**AMB4 – Replacing Steering Column Screws on Steering Gear (Recall Campaign)**

Model Line: **Cayenne (9YA/9YB)**

Concerns: **Steering column screws on steering gear**

*Installation position of steering column screws*

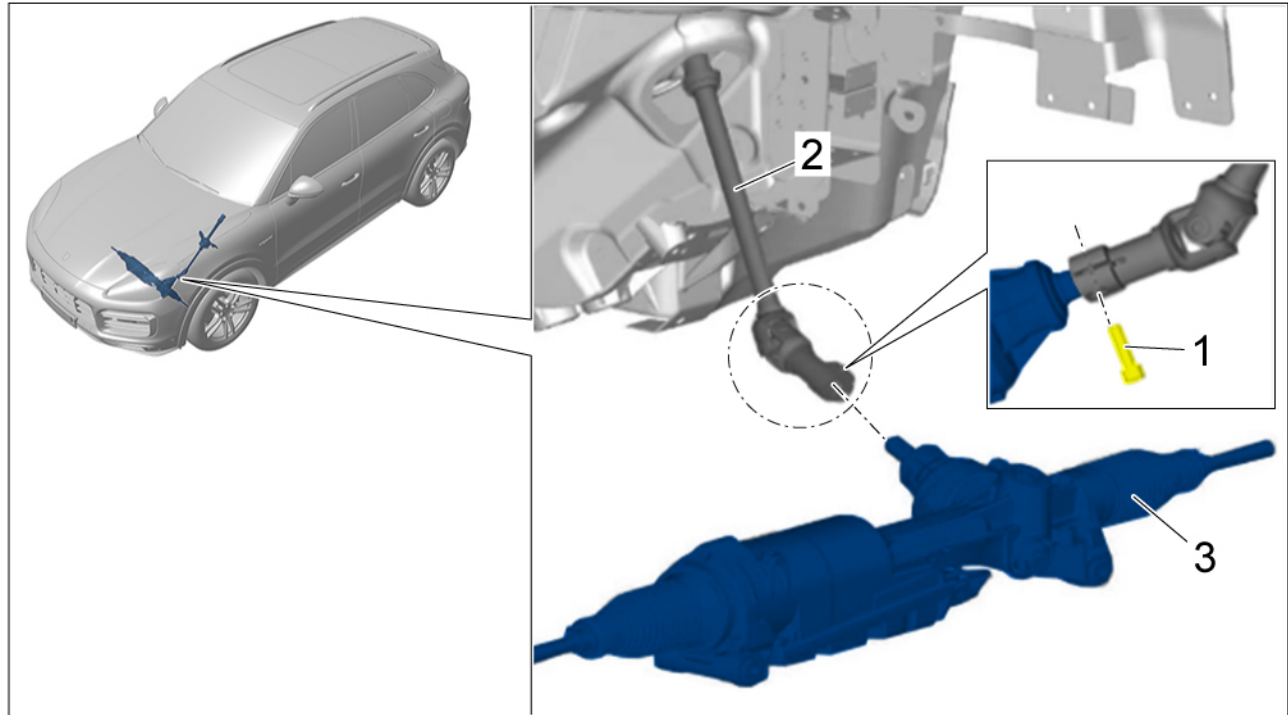
Information: **Due to a process error during production, there is a possibility that the threaded connection securing the steering column to the steering gear does not meet the required specifications on the affected vehicles.**

If this is the case, the steering column can become detached from the steering gear over the service life of the vehicle. As a result, we cannot rule out the possibility that the steering will fail.

Action required: Replace steering column screws on the steering gear.

- 1 – Fastening screw securing steering column to steering gear (replace)
- 2 – Steering column
- 3 – Steering gear
